# DCAS testing campaign

## Driver Monitoring System

DCAS Meeting  
Brussels 13-16 May 2024

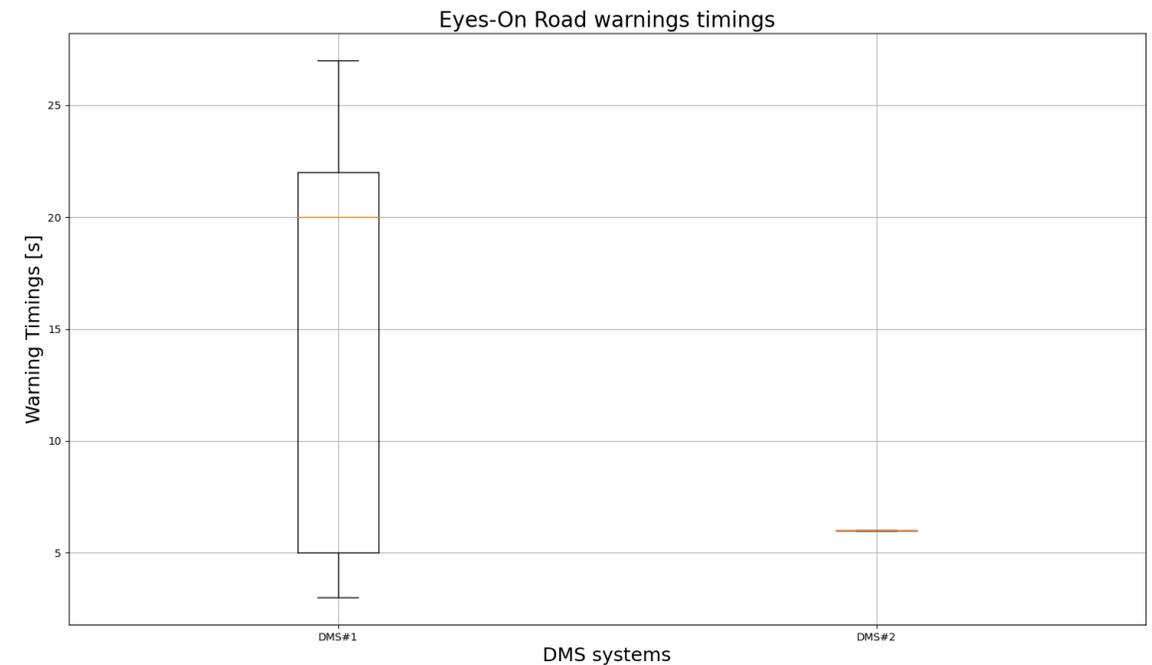
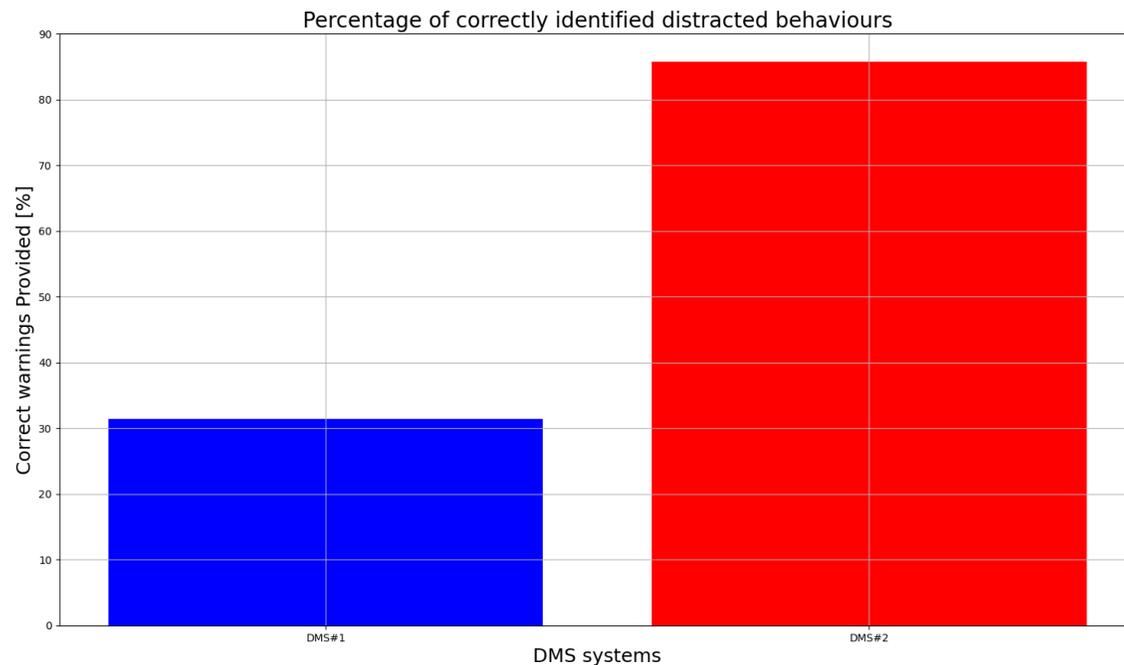
When wearing sunglasses drivers were able to stay distracted indefinitely without receiving any warning from the DMS.

Some **DMS** works **in the RGB** spectrum and are inherently **unable to prevent** this kind of misuse. They mostly **relied on head position** allowing drivers to watch Netflix or reading a book, as long as placing it high enough (e.g., on the steering wheel or in front of the IC)

The ones working in the infrared (**IR or NIR**) decided to **discard data from eyes** and consider only the head orientation, **allowing the same behaviours** as for RGB cameras. To be noted that, both sunglasses with high and low transmittance have been adopted. If this is **admissible with low transmittance** sunglasses, it shouldn't be condoned with the others, which looks as normal corrective glasses to the camera.

## 5.3.5. Response to System boundaries

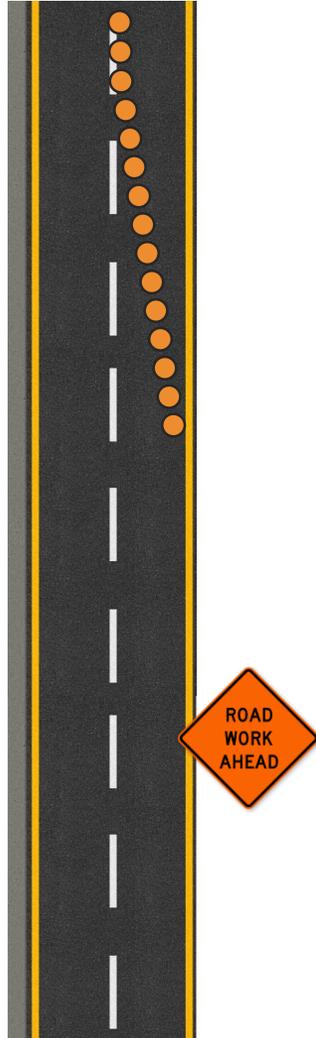
The system would benefit if the driver are made timely and clearly informed about how they should react in order for the situation to stay controllable.

In short, anticipatory behaviour would largely benefit DCAS systems, especially Eyes-On-Warning only

**Event from system #1:**

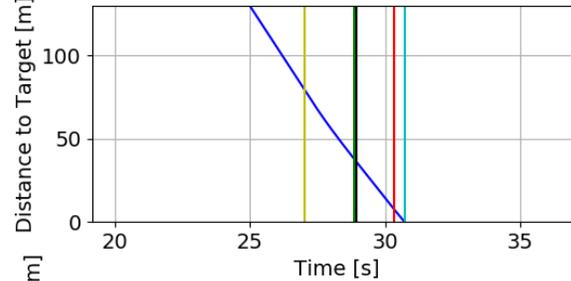
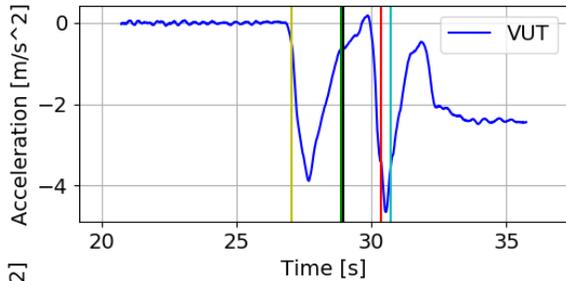
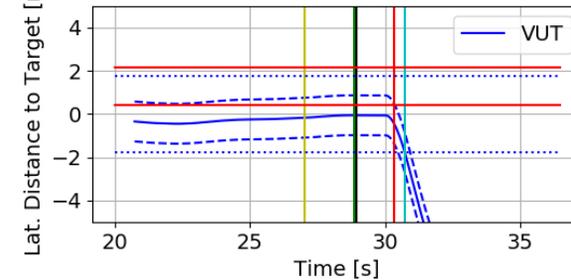
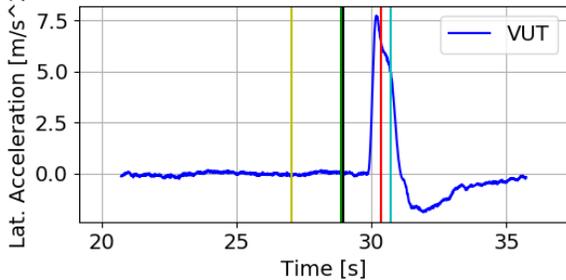
System warned for imminent collision at around 1.75s before collision (TTC)

Started decelerating when TTC was 3.31s

Safety drivers had to steer away to avoid crash at around 1s of TTC

Driver could notice 3.31s the deceleration and had little time to react.

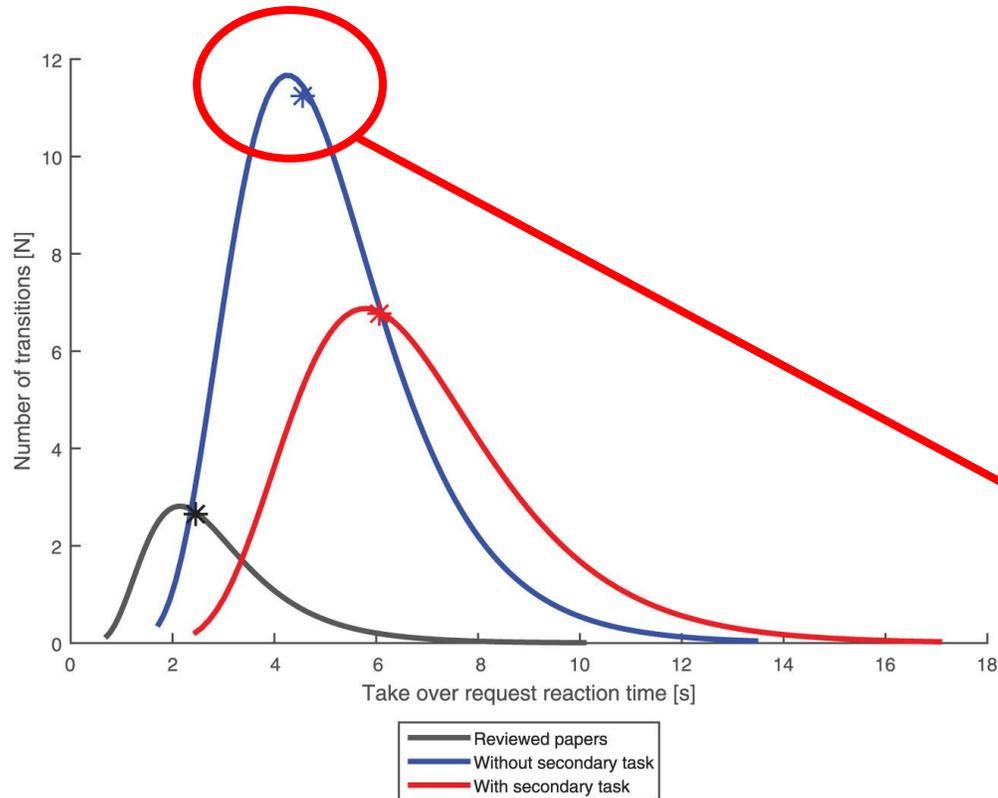
Likewise, we see that decision-making process must be considered to ensure controllability during manoeuvres.

This means that the system should make sure the drivers were aware of the situation before initiating (SIM) or proposing (DCM) a manoeuvre
